From:	edjepsen tds.net [edjepsen@tds.net]
Sent:	Monday, May 10, 2010 8:42 AM
To:	Cnare, Rebecca; Simon, Debra
Cc:	Rummel, Marsha
Subject:	Edgewater Hotel issues
Follow Up Flag:	Follow up
Flag Status:	Flagged

Edgewater Project Visual Impact Summary

The Landmarks Ordinance Allows for One and Only One 200-foot VRA Circle

Exhibit A: The VRA circle that would result when measuring "not a corner parcel" using the "streetside (front) lot line"

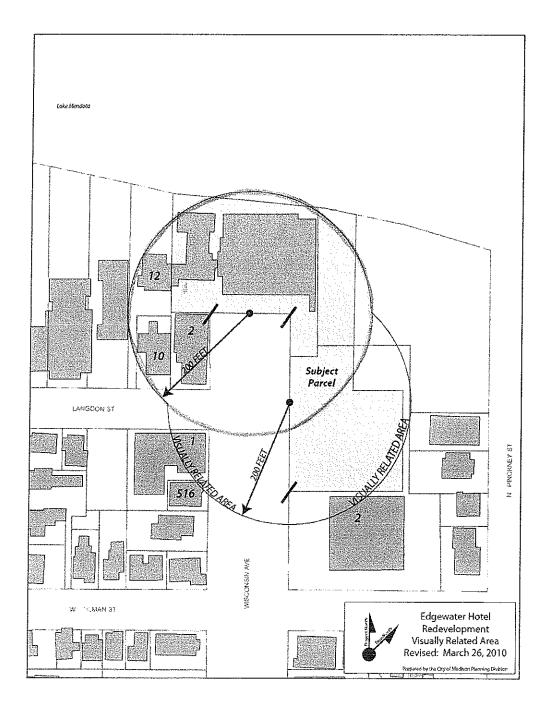
Exhibit A: When a parcel is "within a block" and "not a corner," the VRA circle is drawn "from the centerpoint of the streetside (front) lot line." The "streetside (front) lot line" for the Edgewater is the area (shown in yellow on Exhibit A) that is the *front* of the 1940s building and 1970s addition, *front* of the current building entrances, *front* of the lake, and will be the *front* of the new tower, *front* of the public space, *front* of the stairway to the lakefront, and *front* of the property as a whole. The resulting VRA using the "streetside (front) lot line" is shown in red on Exhibit A.

Exhibit B: The VRA circle that would result when measuring "not a corner parcel" using two streetsides (front and side lot lines).

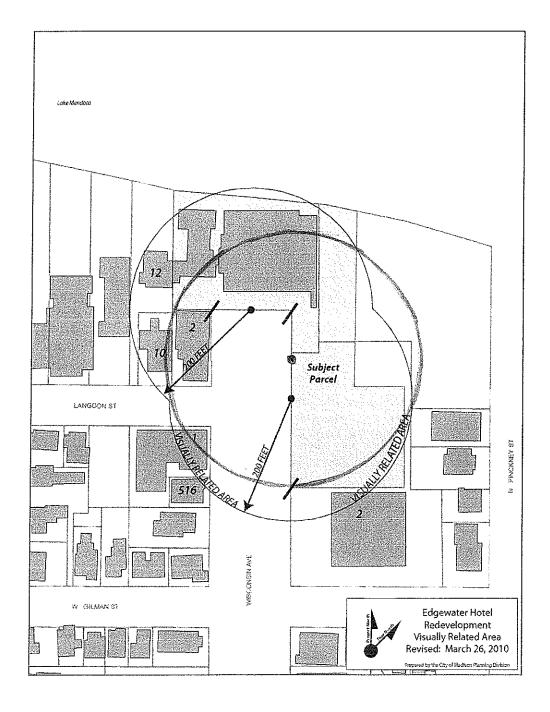
Exhibit B: Even if the Landmarks Commission ignored the "front" streetside requirement and considered both streetsides (as shown in yellow in Exhibit B, the front lot line plus the side-yard lot line) and divided this total frontage in half to arrive at the "centerpoint," the resulting VRA is shown in red on Exhibit B. This would be a overly generous interpretation because (1) the ordinance allows for only one "streetside" as that term is singular and not plural; and (2) the one "streetside" must be the "front" streetside, which would be the front of the parcel, lakefront and buildings — not the peripheral side yard.

Exhibit C: The VRA circle that would result when measuring "a corner parcel" using the diagonals from the "principal corners."

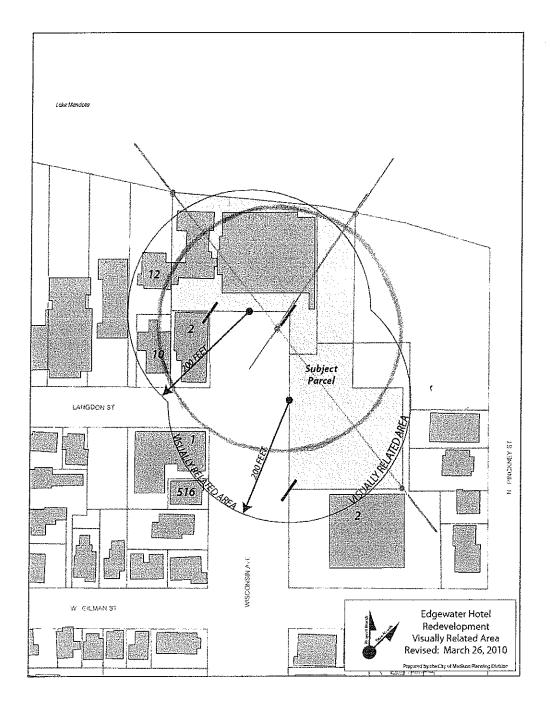
Exhibit C: Even if the Landmarks Commission determined that the subject parcel were "a corner parcel" (and, thus, rejected city's conclusion that it is "not a corner parcel"), only one VRA circle would still result (shown in red on Exhibit C) when drawn from the "principal corners" of the parcel. These principal corners make sense for at least two reasons. First, it defines the principal corners as the two lakefront corners, the front entrance corner and the far lot line corner. It also centers the VRA over the mass, which is logical, given that the purpose of the VRA is to compare the proposed building mass against other existing building masses within the visually related area.
